Technical Service Information

MERCEDES BENZ 722.6

TCM FLUID CONTAMINATION

Figure 1

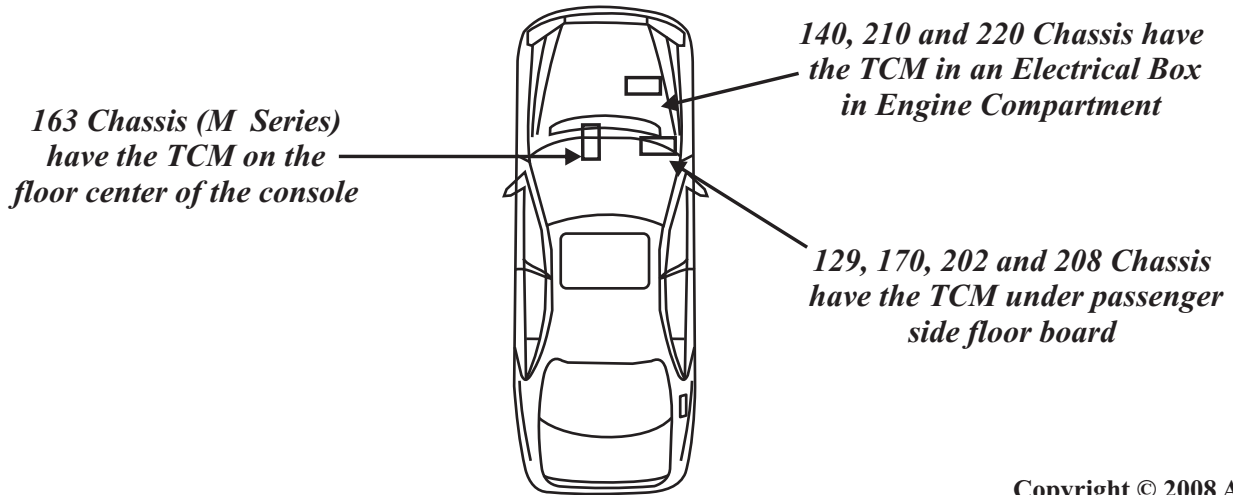
COMPLAINT: The vehicle may experience intermittent speed sensor or solenoid codes with reoccurring limp mode. When the technician locates the TCM, (Refer to Figure 1), to do some electrical checks, the TCM is found to be full of transmission fluid.

Figure 2

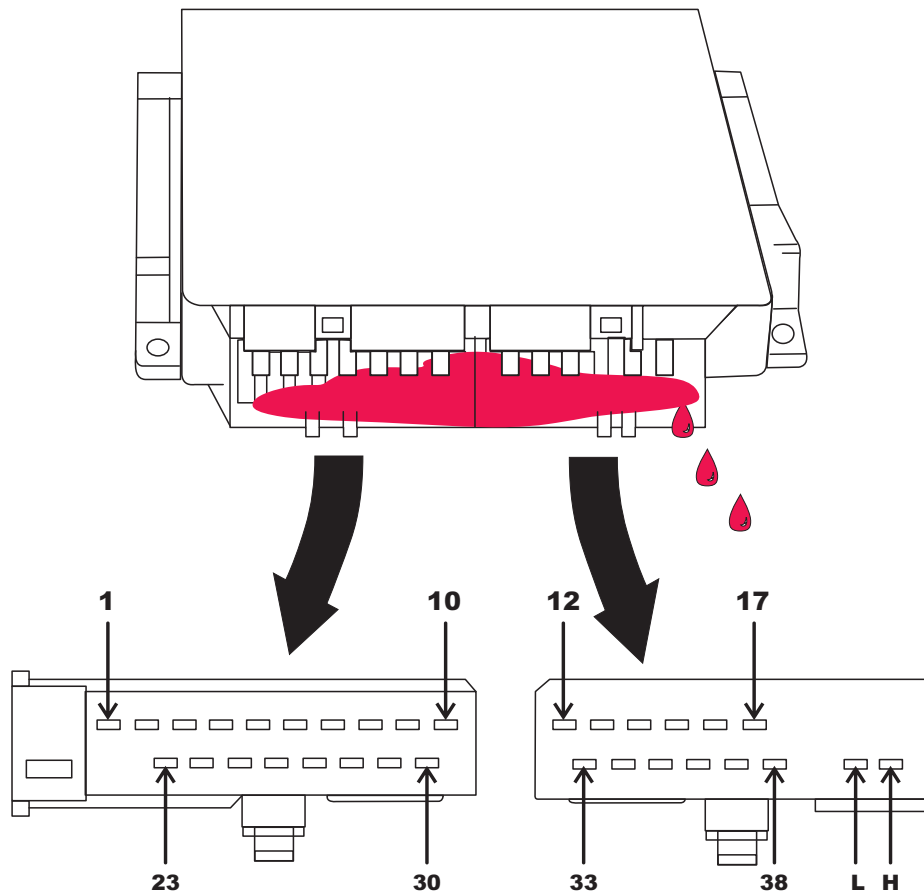
CAUSE: Transmission Fluid has worked its way up the wiring between the transmission case connector and the TCM through capillary action. As a result of this action, the TCM has been filled with fluid, (Refer to Figure 2).
This has nothing to do with the with seal condition on the conductor plate or the vehicle harness connector, even with good seals this will occur, (Refer to Figure 3).
